Seabrook Station ASR Methodology LAR: Structural Deformation

LAR 16-03

Methodology and Responses to RAIs D2-D8

November 17, 2017

RAI-D8

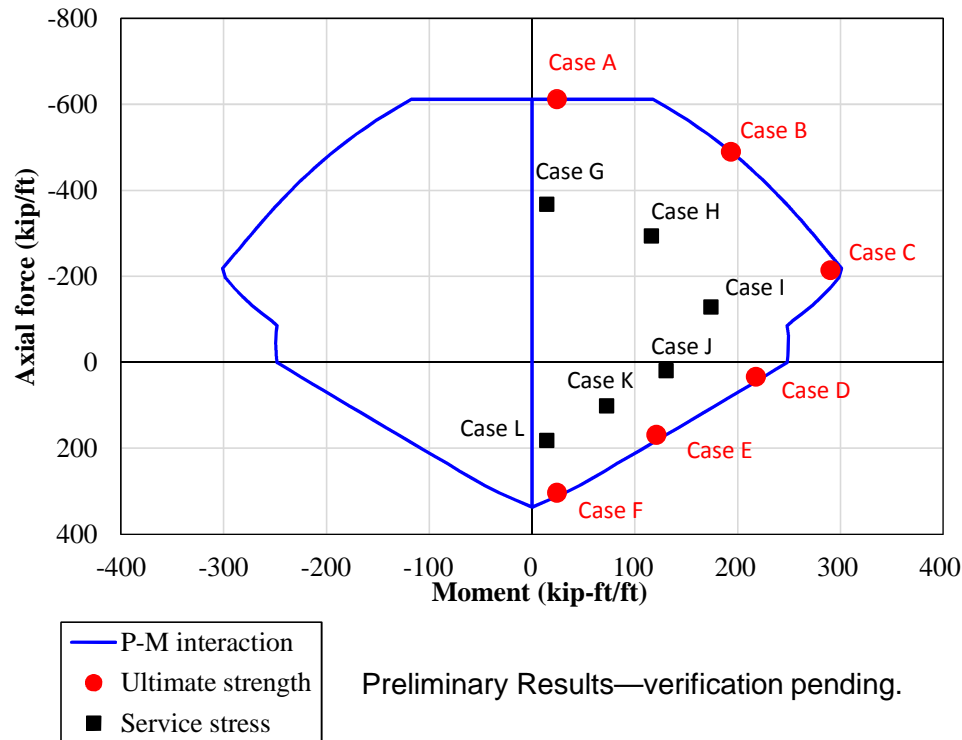
Request - Explain, with sufficient technical detail, how the proposed method of evaluation for ASR-affected structures verifies that the stresses and strains in the concrete and reinforcement remain within elastic limits based on realistic behavior under normal operating (service) load conditions, including ASR load.

Response

- **Compliance with the ACI Code, as supplemented by the Methodology Document, ensures structures behave elastically, and the rebar and concrete stresses and strains remain within acceptable limits.**
